PMA Conceptual Consistency

David Law
3COM

John D'Ambrosia
Force10 Networks

- This presentation addresses comments 134, 142, 143, 157, and 158
- The P802.3ba PMA addresses
 - Two rates
 - Multiple PMD types, i.e. # of lanes and lane rates
 - Physical interconnect, i.e. XLAUI / CAUI
 - Future implementations of PMDs and physical interconnects
- But, conceptually, what is the “PMA”?
 - A single black box that consists of multiple PMAs?
 - Multiple PMAs?

Figure 83–2—40GBASE-R and 100GBASE-R PMA layering

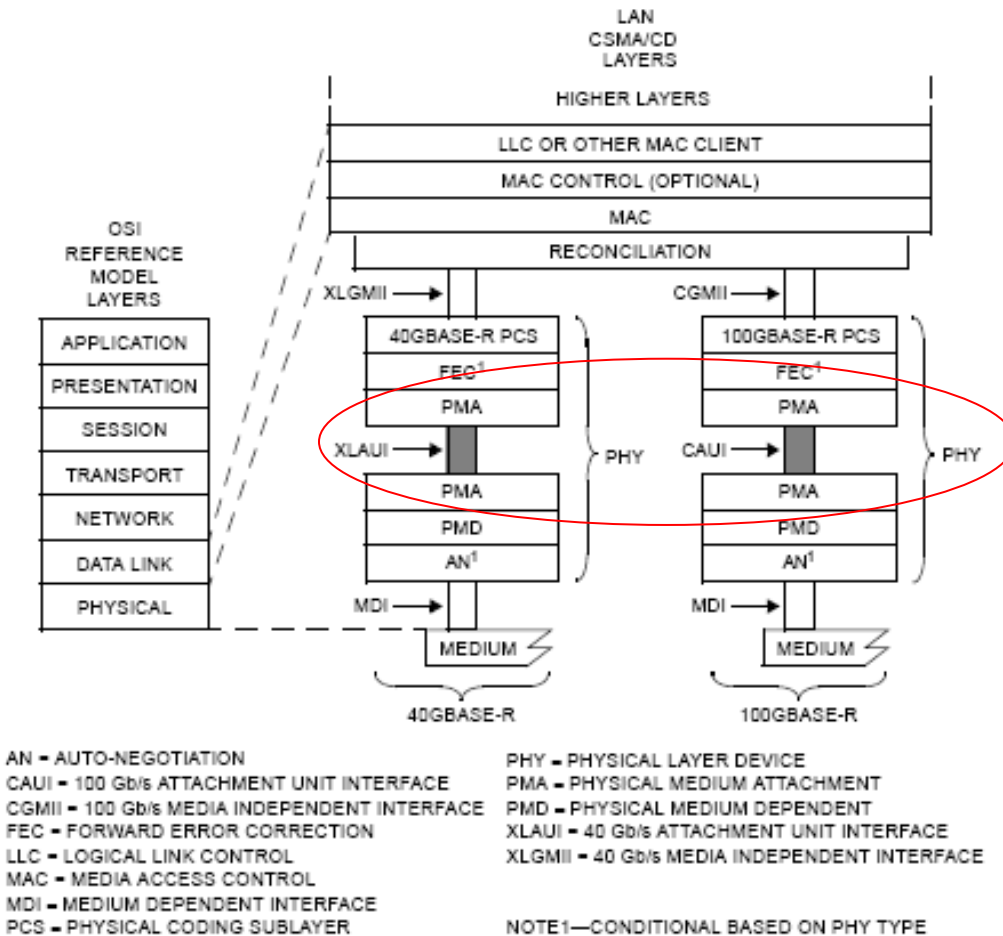
Per 83.1.4 –

The PMA is modeled in stages as illustrated in Figure 83–2. Each stage of the PMA recombines the virtual lanes originating from the PCS from m PMA input lanes to n PMA output lanes.

Various stages of the PMA are optional, depending on the number of lanes required for a particular PMD and whether there is a need for an extender sub-layer (XLAUI/CAUI). A PMA with an equal number of input and output lanes is used to provide retiming and signal drivers, if required.

Figure 83A-1—40 Gb/s and 100 Gb/s attachment unit interface relationship to the ISO/IEC Open Systems Interconnection (OSI) reference model and IEEE 802.3 CSMA/CD LAN model

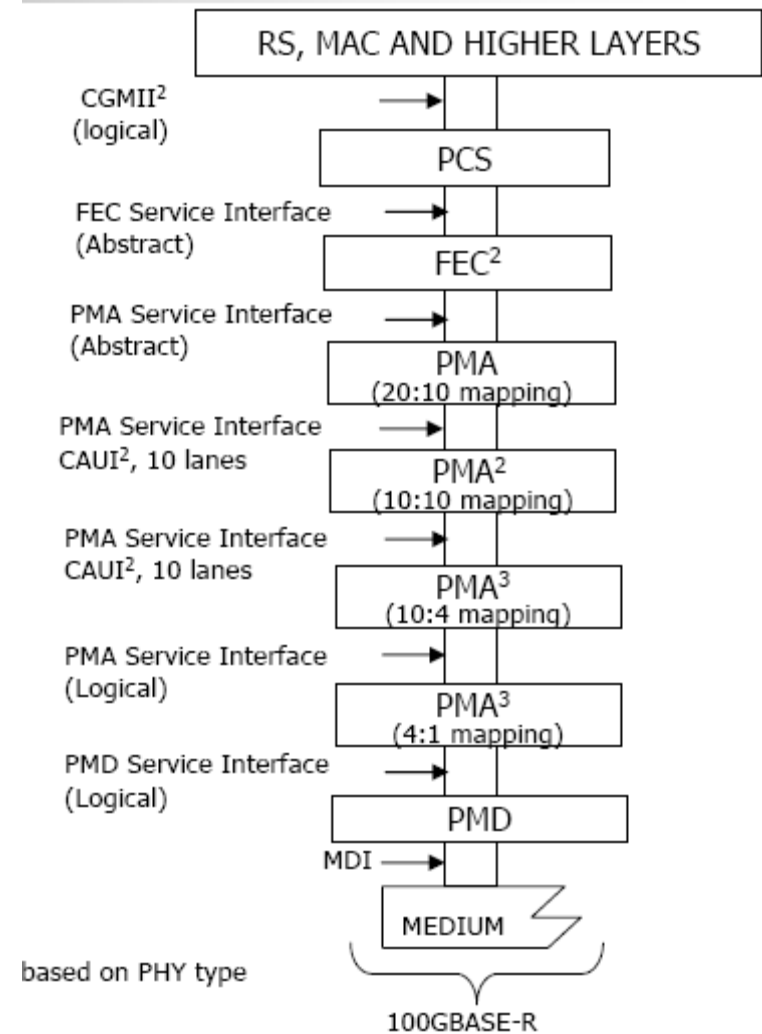
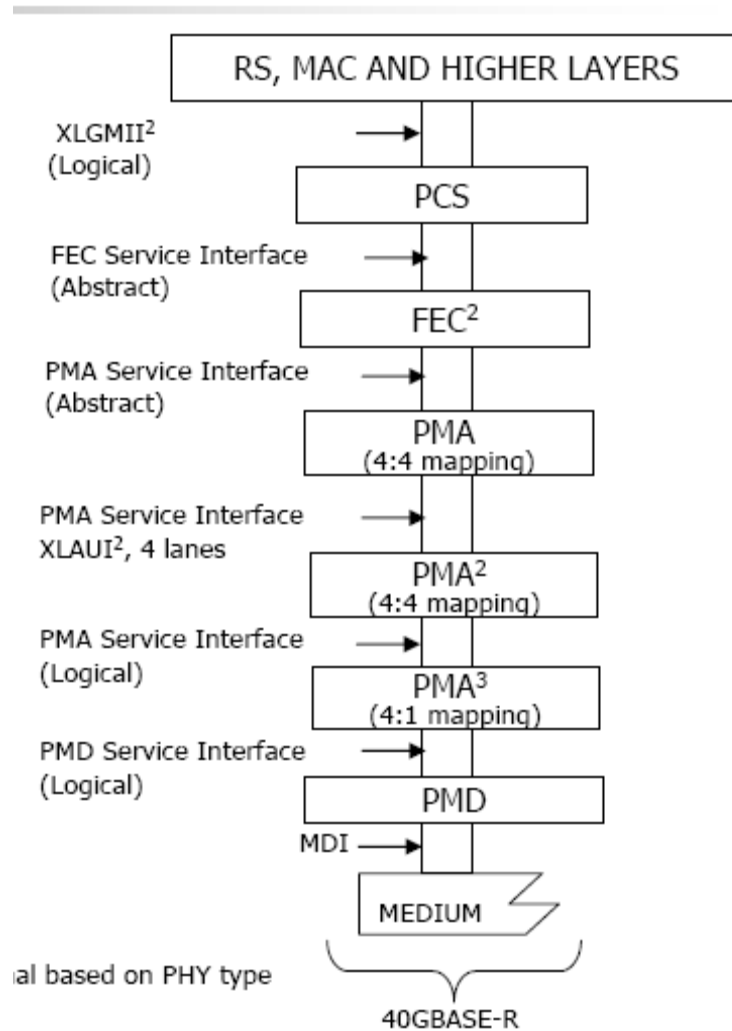
- PMA doesn't appear as stages
- “PMA” labeling boxes above and below XLAUI / CAUI imply boxes have identical functions
- XLAUI / CAUI exists between stages of PMA, not between two different PMA
